NOTICE OF ADMINISTRATIVE DECISION

DATE: July 31, 2024
FILE NUMBER: 311-24-000041-PLNG
APPLICANT: CK Designs, LP
APPLICANT REP.: Barghausen Consulting Engineers, Inc.
PROPERTY OWNER: CK Designs, LP
LOCATION: 3605, 3619, 3627 & 3641 Pacific Avenue
Washington County Tax Lots: 1N332DC01000, 1N332DC00901,
1N332DC00902 & 1N332DC06300
PROPOSAL: Site development and design review approval for a fueling station,
convenience store (4,270 square feet) & car wash (2,607 square
feet)

FINDINGS AND CONDITIONS
PROPOSED FUELING STATION AND CAR WASH
File Number: 311-23-00041-PLNG

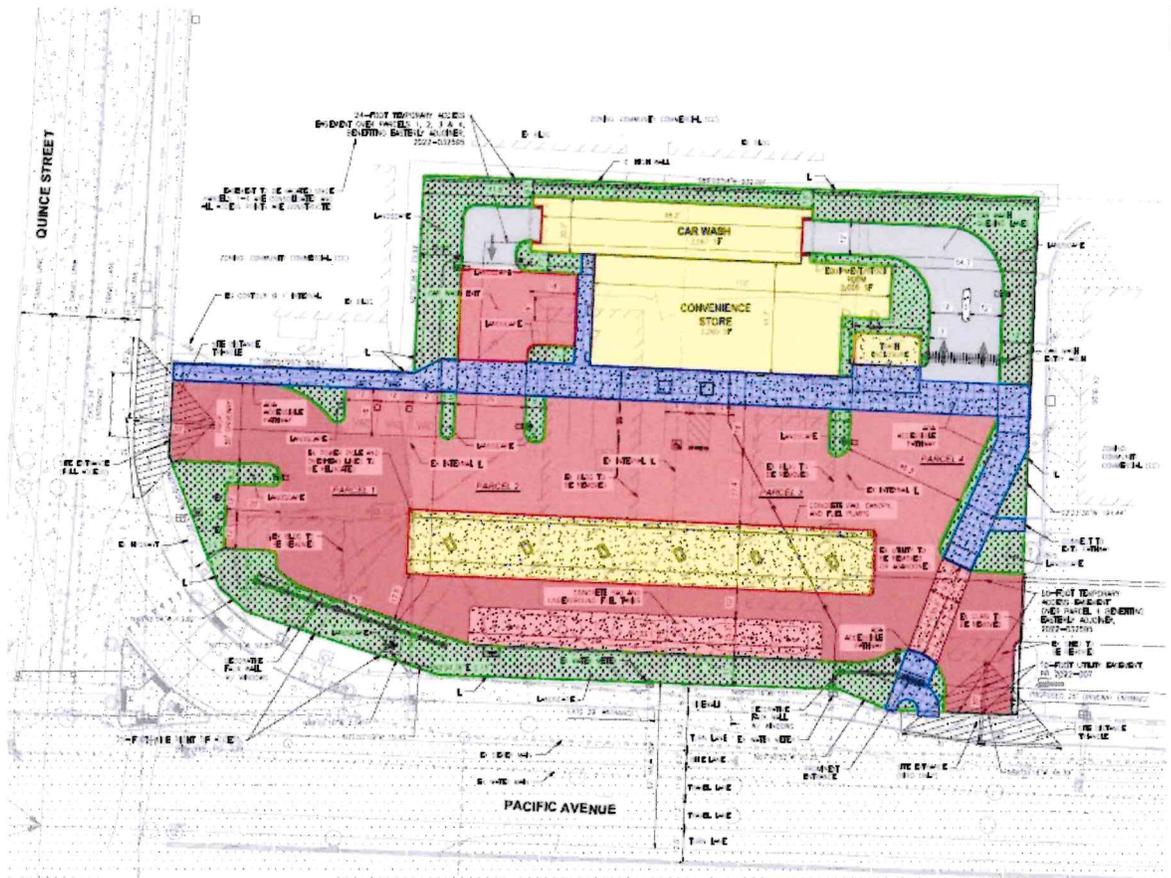
- The proposed curblines at the point of cross access does not appear to line up with our existing curblines. Can you require that the curblines match for a more cohesive development?

The plans submitted by the applicant show a “jog” in the internal curb connectivity as shown on the image below.

- What will be required on the back side of our landscaped island. The site plan provided currently does not show anything.

The City's Development Code or Engineering Construction and Design Standards and Specifications do not address property curb connectivity outside of the public right-of-way. Therefore, the City cannot require that the applicant match the curbline for a more cohesive development.

As the image below shows, the subject property currently lacks landscaping. The applicant proposes landscaping improvements as part of the development.

Proposed landscaping, shown in green on the image below, includes a 6-foot-wide landscaped strip along the property line separating the commercial development from the residential area to the north consistent with the Development Code. A landscaped area with ground cover is also proposed along the eastern site perimeter outside of the vehicle maneuvering and pedestrian areas.

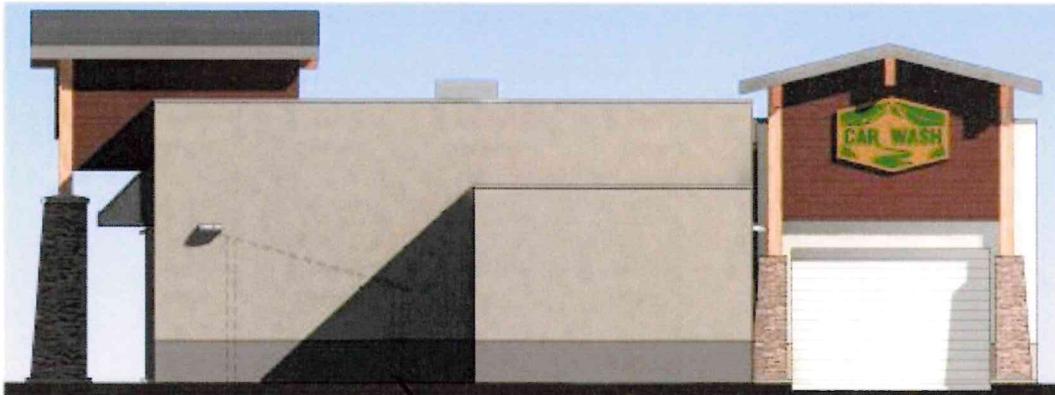
- What does this development have planned for signage? Would there be any opportunity for additional signage for our project?

The applicant provided an architectural plan set that provides a concept for signage.

In addition to the wall signs shown above, the Development Code allows monument and pylon/pole signs in the Community Commercial zone. The applicant did not provide details for monument or pylon/pole signs. The applicant may apply for sign permits at a later date for these signs. Monument and pylon/pole signs are subject to the following requirements.
